NACELLE - EXHAUST – "MINOR" TRACK LINER, THRUST REVERSER – REPLACEMENT /
"MAJOR" TRACK LINER - INSPECTION
(NON-MODIFICATION)

V2500-D5

July 30, 1999

V2500-NAC-78-0176

Upper Thrust Reverser Half Track Liner Removal/Installation Figure 1 (sheet 1)

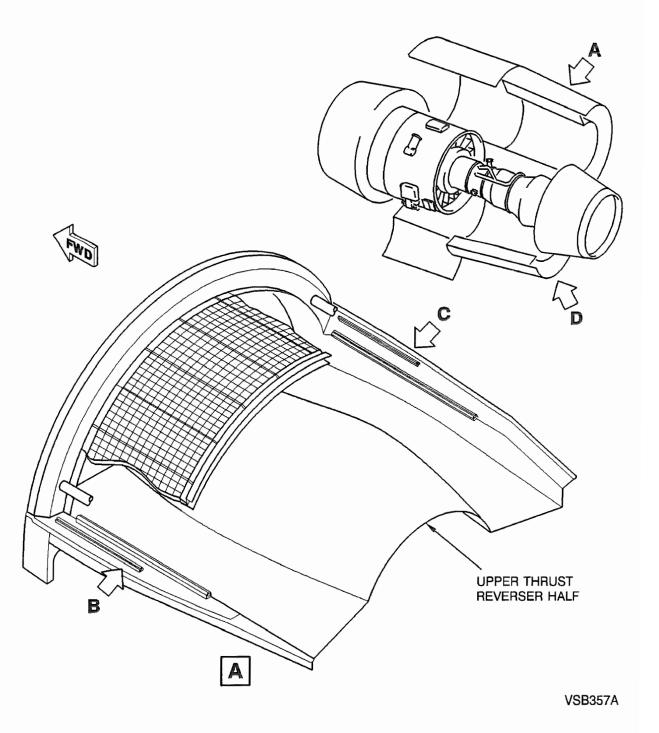
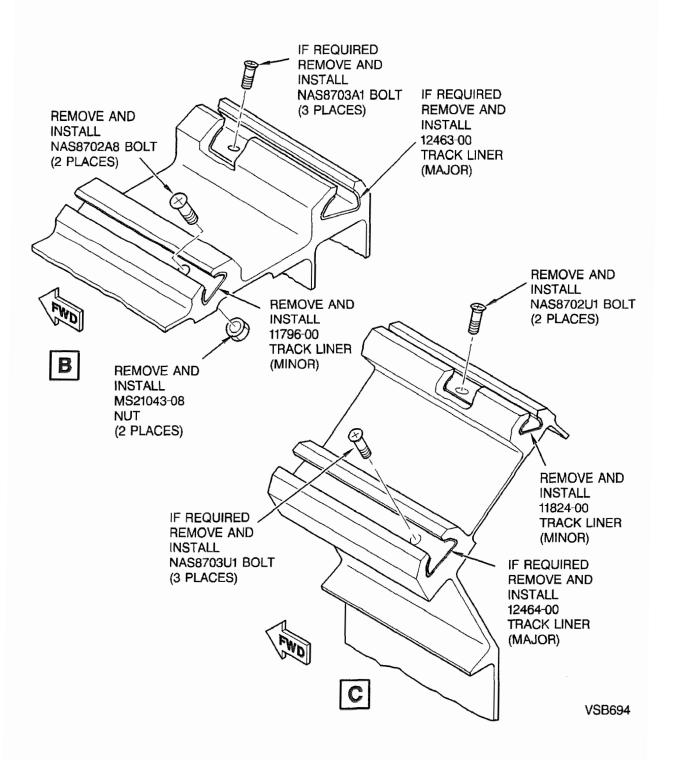
- (1) Remove the upper and lower outboard "minor" track liners. Refer to Figures 1 and 2.
 - (a) Remove the bolts and track liners from the track beams. Discard the track liners and any damaged bolts.
- (2) Remove the upper and lower inboard "minor" track liners. Refer to Figures 1 and 2.
 - (a) Make two small cuts in the heatshield to expose the MS21043-08 nuts.
 - (b) Remove the nuts, bolts, and track liners from the track beams. Discard the track liners and any damaged bolts or nuts.
- (3) Examine the track beams for damage. If you find damage, contact your Rohr representative for disposition.
- (4) Install the upper and lower inboard "minor" track liners. Refer to Figures 1 and 2.

- (f) Mix the sealant (CoMat 08-030). Refer to the manufacturer's instructions.
- (g) Apply sealant (CoMat 08-030) to cover the cuts in the heatshield.
- (h) Cure the sealant. Refer to the manufacturer's instructions.
- (5) Install the upper and lower outboard "minor" track liners. Refer to Figures 1 and 2.

- (a) Install the track liners on the track beam with the bolts and nuts.
- (b) Torque the MS21043-08 nuts to 12-17 lb in (1,4-2.0 Nm.).

- (a) Install the track liners on the track beam with the bolts.
- (b) Torque the bolts to 15-20 lb-in (172-2,3 Nm.).
- (6) Examine the upper and lower inboard and outboard "major" track liners for damage. Use a mirror. If you find damage, replace the track liner as follows:
 - (a) Remove the bolts and the track liner from the track. Refer to Figures 1 and 2.
 - (b) Examine the track beam for damage. If you find damage, contact your Rohr representative for disposition.
 - (c) Install the new track liner and bolts on the track. Torque the NAS8703A1 and NAS8703U1 bolts to 15-20 lb-in (1,72-2,3 Nm.).
